BAW-2168

RESPONSE TO GENERIC LETTER 92-01
FOR VIRGINIA ELECTRIC & POWER COMPANY
NORTH ANNA UNIT 1 AND
NORTH ANNA UNIT 2

Prepared for
Virginia Power Company

SUBJECT: REACTOR VESSEL STRUCTURAL INTEGRITY, 10 CFR 50.54(f)
(GENERIC LETTER 92-01, REVISION 1)

TABLE 8. GENERIC LETTER 92-01 RESPONSE: SECTION 3, ITEM a

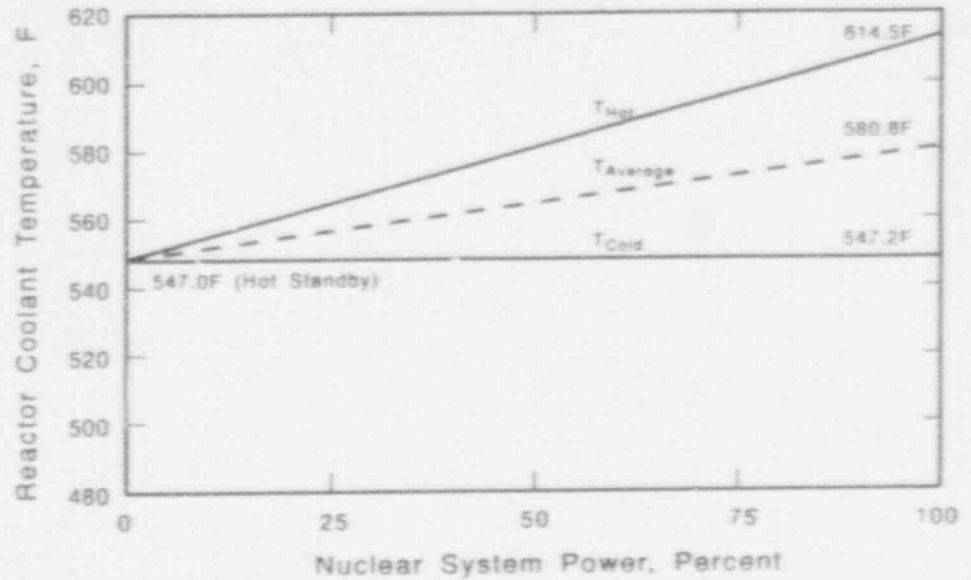
If T_{cold} is $<525^{\circ}F$, state how this was considered in determination of embrittlement effects (C_{USE} , RT_{NDT}) in accordance with Regulatory Guide 1.99, Revision 2:

Not Applicable
(see Figure for current design operating temperatures)

TABLE 8. GENERIC LETTER 92-01 RESPONSE: SECTION 3, ITEM a

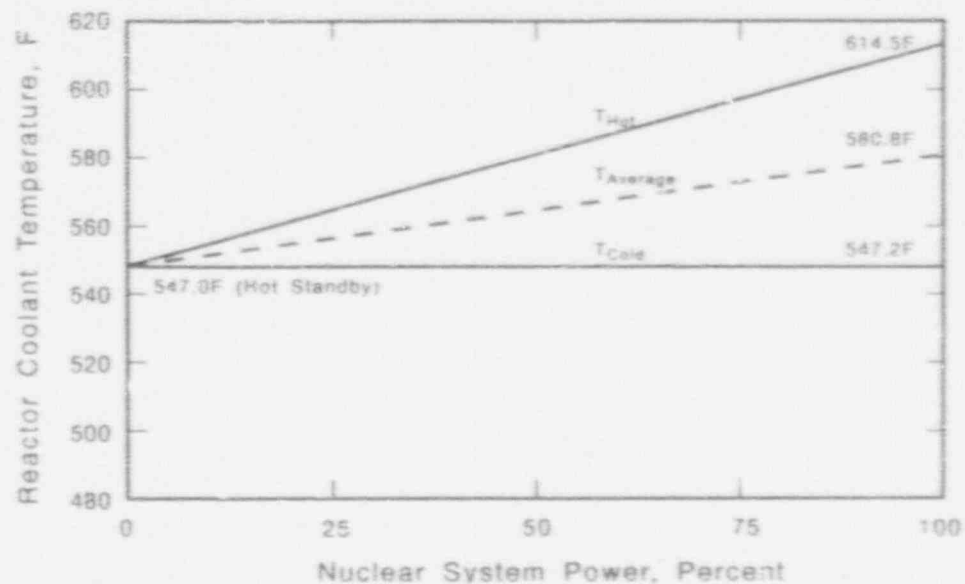
If T_{cold} is <525°F, state how this was considered in determination of embrittlement effects (C_{USE} , RT_{NOT}) in accordance with Regulatory Guide 1.99, Revision 2:

Not Applicable
(see Figure for current
design operating
temperatures)
